**SIGN-24-79****Sign Permit**

Install Freestanding Off-Premise Advertising Sign with LED Digital Faces

Review of Sign Permit Application

RE: Sign Permit: SIGN-24-79
2410 S Cobb Dr
17034600250

Diagram of Proposed Sign

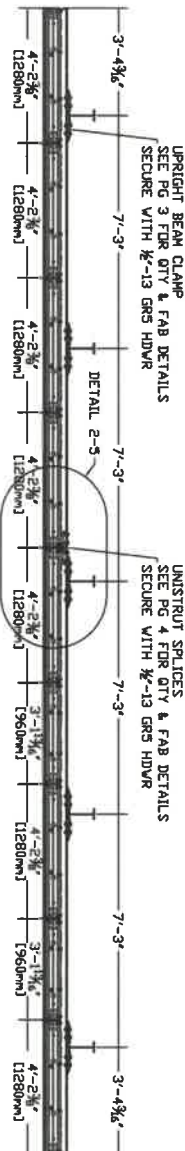
This sign permit is denied based on the non-compliance with the regulations established in Chapter 82, Section 15 of the Smyrna Code of Ordinances. The proposed sign exceeds both the maximum area (32 square feet) and maximum height (8 feet) specified by the ordinance, is not a ground based monument sign as required by the ordinance and is a pole sign as prohibited by the ordinance.

The application for permit SIGN-24-79 is denied based on the non-compliance with the regulations established in Chapter 82, Section 15 of the Smyrna Code of Ordinances. The proposed sign exceeds both the maximum area (32 square feet) and maximum height (8 feet) specified by the ordinance, is not a ground based monument sign as required by the ordinance and is a pole sign as prohibited by the ordinance.

Also, this sign would exceed the number of allowable signs at this location because there is already one ground based monument sign at this location.
